Technical Service BULLETIN

SEAT CUSHION HEIGHT ADJUSTMENT HANDLE IMPROVEMENT

'03 – '04 4Runner

BO013-04

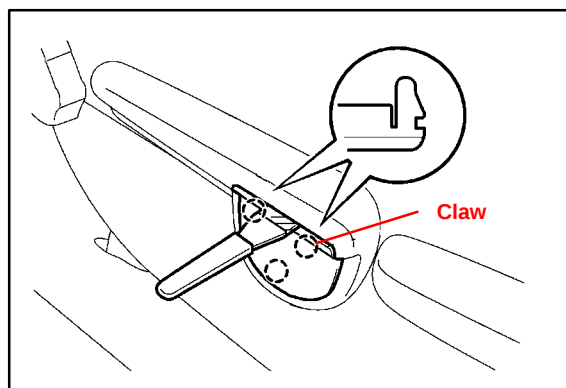
Introduction Some 2003 and 2004 model year 4Runner vehicles may experience a condition where the seat cushion height adjustment handle is contacted while entering or exiting the vehicle causing the seat adjustment to change. A new seat cushion height adjustment handle has been developed to correct this condition.

PREVIOUS PART NUMBER	CURRENT PART NUMBER	COLOR	PART NAME	QTY
72459-60010-B1	72459-60020-B1	Stone	Cap, Vertical Seat Adjusting Knob	1
72459-60010-B2	72459-60020-B2	Dk. Gray		
72459-60010-E0	72459-60020-E0	Fawn		
72493-60010-B1	72493-60020-B1	Stone	Handle, Vertical Adjusting, No. 2	1
72493-60010-B2	72493-60020-B2	Dk. Gray		
72493-60010-E0	72493-60020-E0	Fawn

1. Remove the seat cushion height adjustment handle No.2.
 - A. Using a screwdriver, disengage the 3 claws and remove the seat cushion height adjustment handle LH.

- B. Remove the 2 screws and the seat cushion height adjustment handle.
2. Replace the seat cushion height adjustment handle with a new service part.
3. Installation is the reverse order of removal.
